**DATE:** 03.27.2018

**FROM:** Mitesh Baxi  
Traffic Engineering

■ **ROLAND GRISE MIDDLE RENOVATIONS [TRC Plan Review #2]**

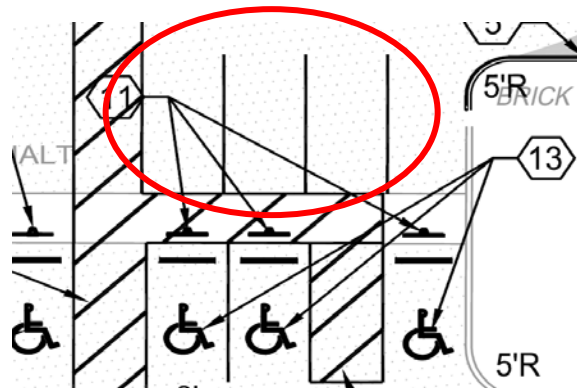
6. Show the typical handicap sign detail on the plan as per ADA and City standards. [Sheets A1 of 5 and A2 of 5, CofW Sign Specification]. Follow the link below.  
<https://www.wilmingtonnc.gov/home/showdocument?id=3940>
7. Please install wheel stops/bollards for the three parking spaces located to the north of the handicap spaces (See below image for the reference). This is to protect the accessible route from the vehicle interference.
